# RENOVATION OF GALEHOUSE (A BUILDING), MCLEOD (S BUILDING), AND NATURAL SCIENCES (N BUILDING)

Cape Fear Community College Wilmington, North Carolina SCO #17-18154-01A; NCCCS #2352 BMG Project No. 2018023.00

#### **ADDENDUM NO. 1**

SCALE:

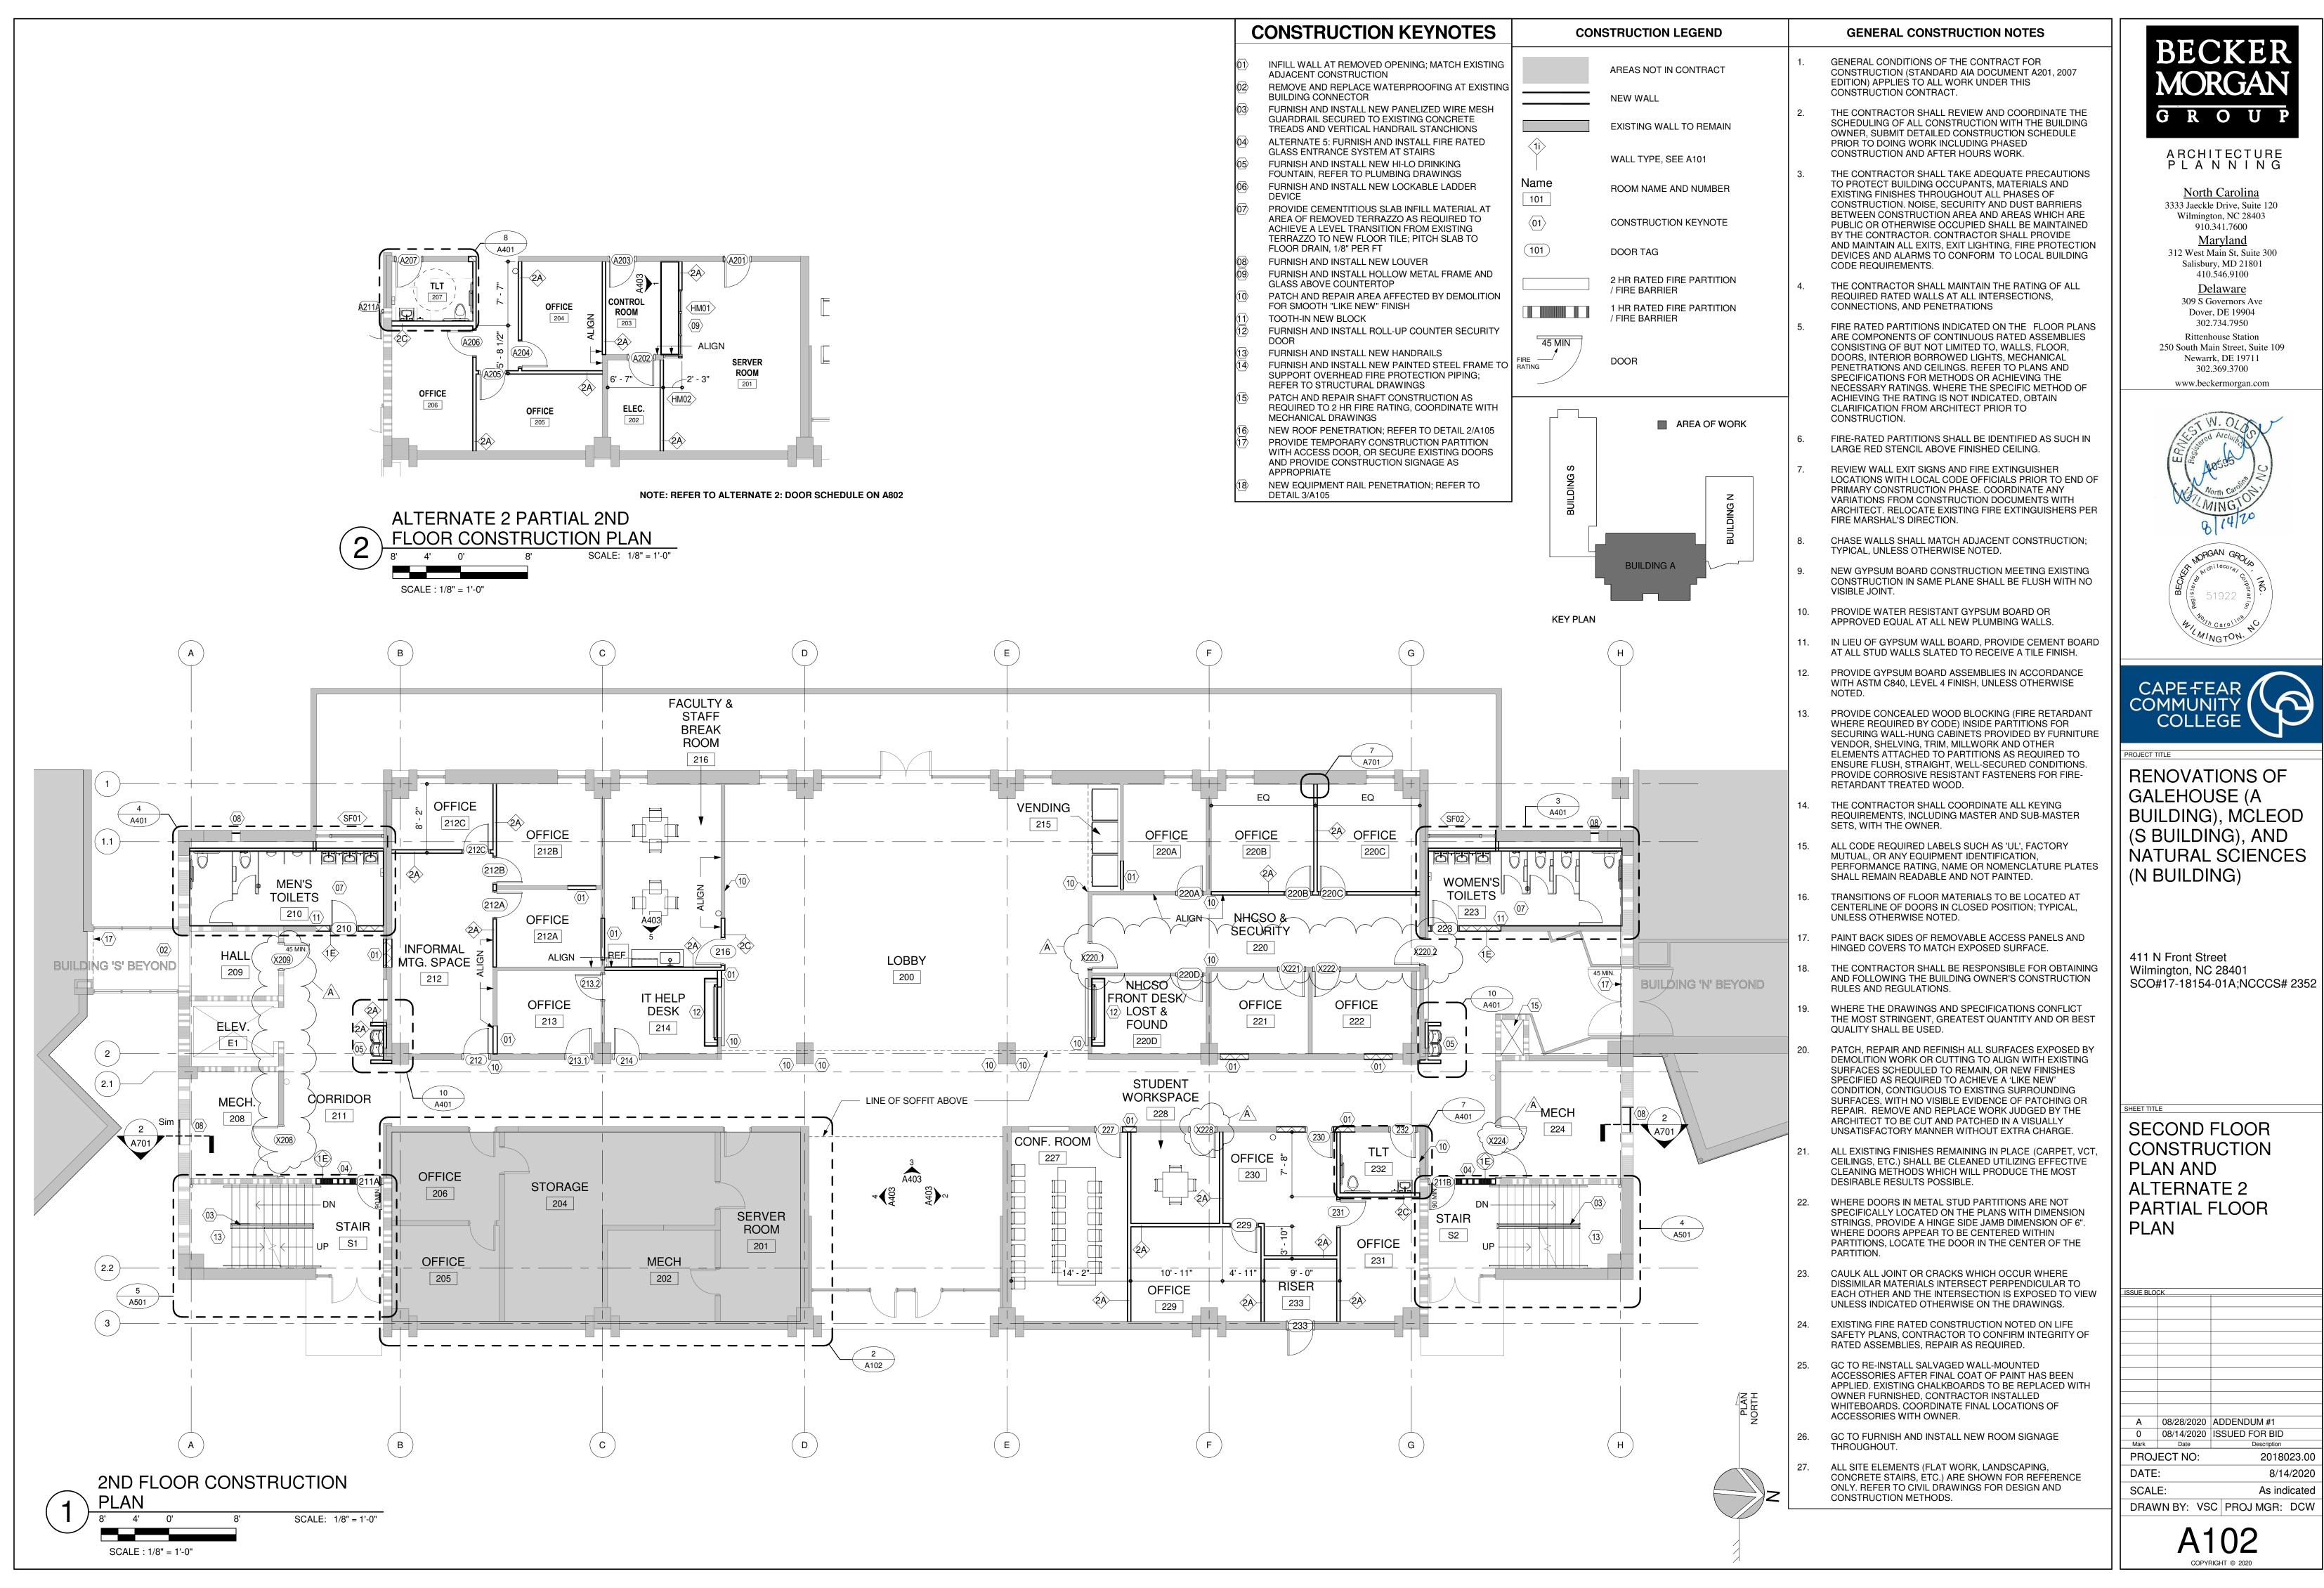
- b. AD101 FIRST FLOOR DEMOLITION PLAN: REVISED. Door shown to be demolished.
- c. A101 FIRST FLOOR CONSTRUCTION PLAN: REVISED. Door tags added.
- d. A101A ALTERNATE 1 FIRST FLOOR CONSTRUCTION PLAN: REVISED. Note regarding alternate doors added.

A802

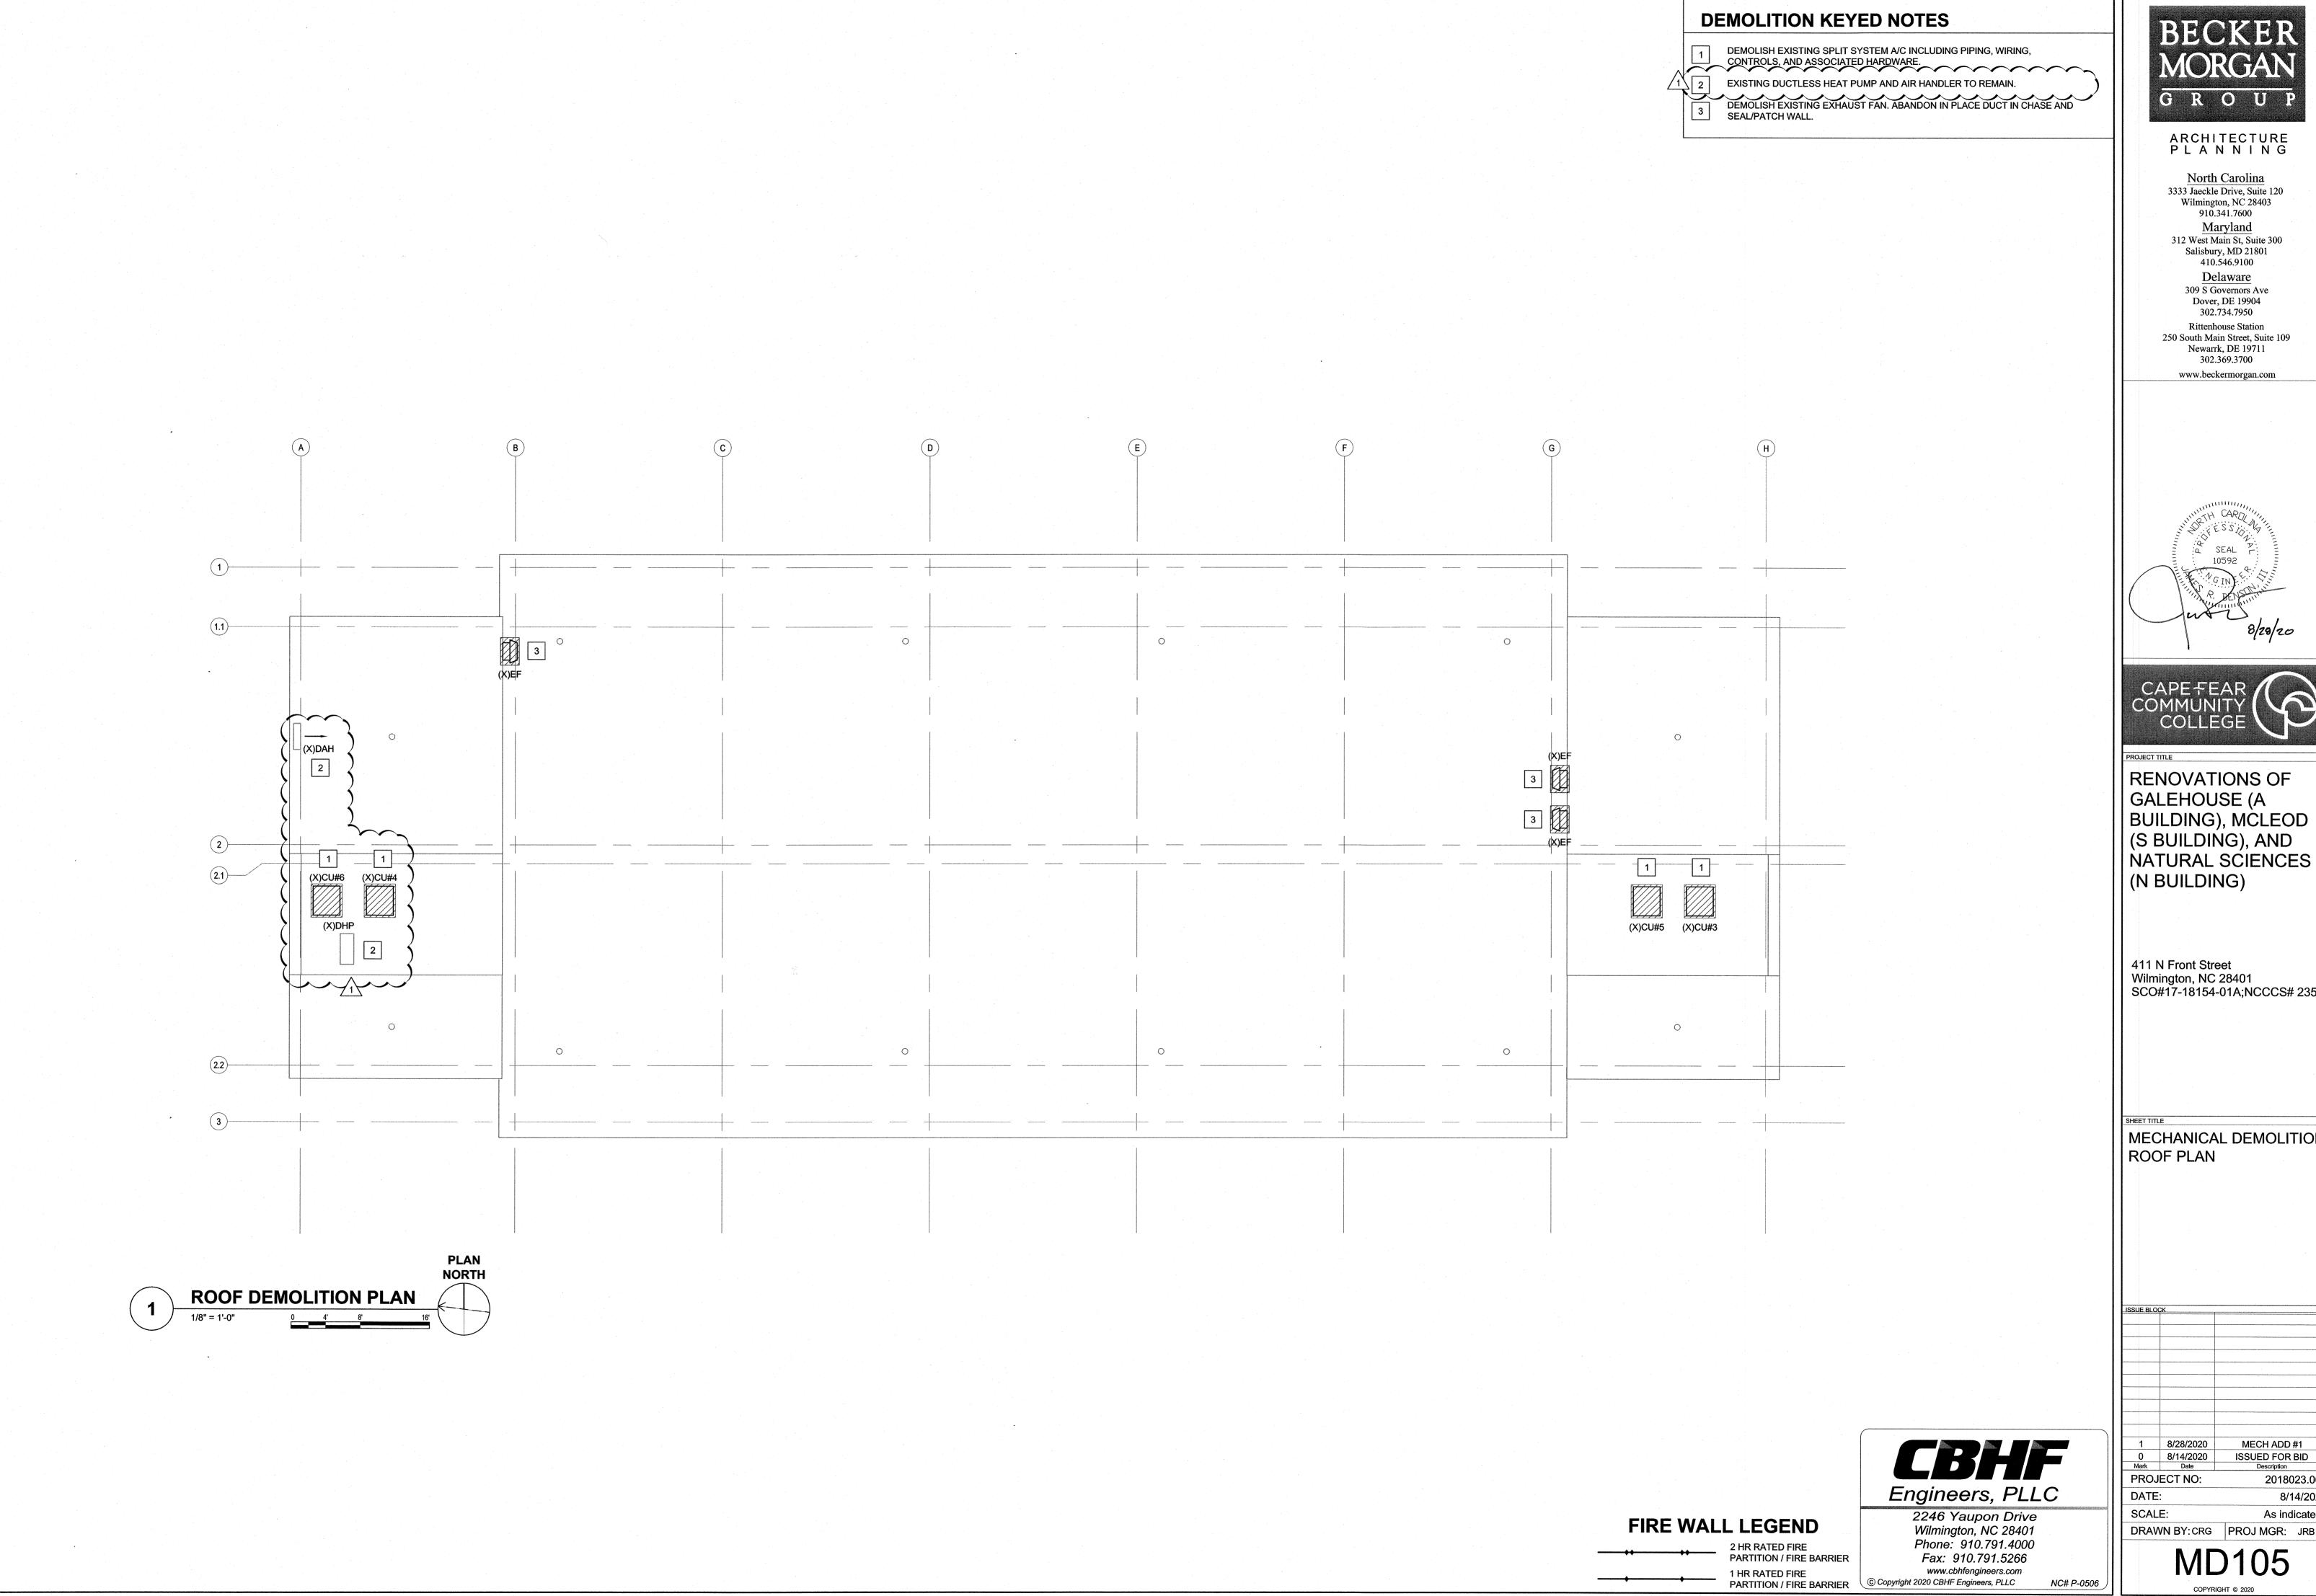
- k. A802 ALTERNATE DOOR AND FRAME SCHEDULE: REVISED. Missing alternate doors added to schedule.
- I. MD105 MECHANICAL DEMOLITION ROOF PLAN: REVISED. Existing ductless heat pump to remain.

E003.1

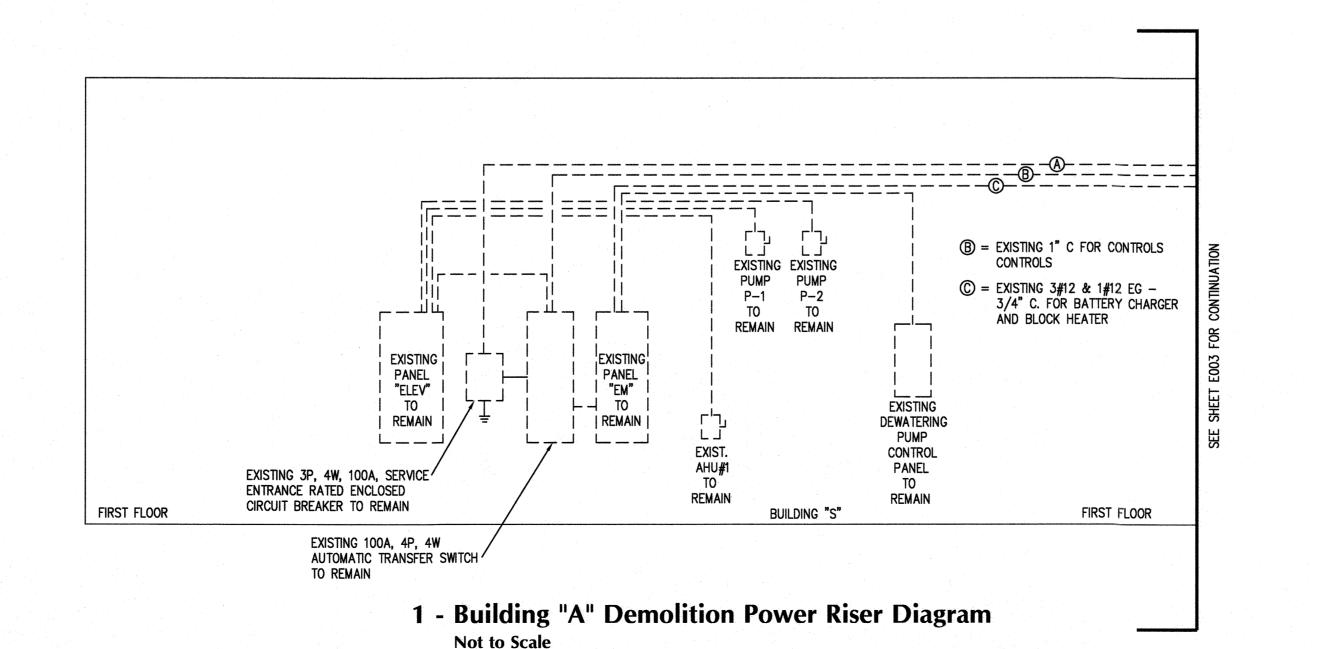
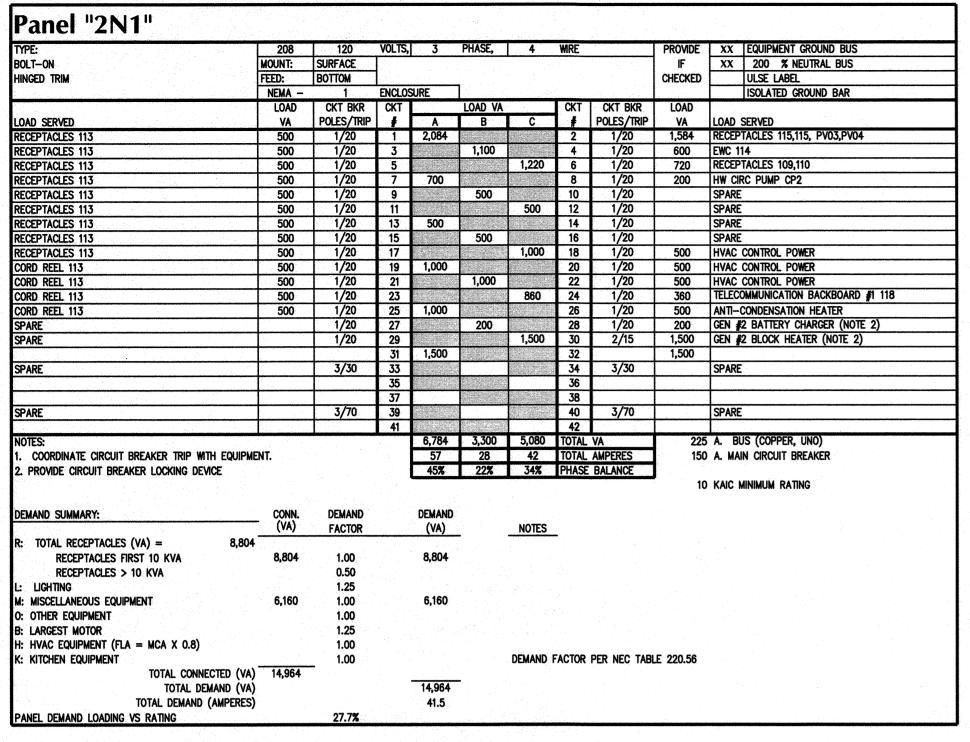
- n. M-602 MECHANICAL SCHEDULES: REVISED. Electric Heater Schedule: Add EUH2.
- o. E003.1 BUILDING "A" DEMOLITION POWER RISER DIAGRAM AND NOTES: REVISED. Abbreviated Electrical Scope of Work Summary and Electrical Distribution System Notes.
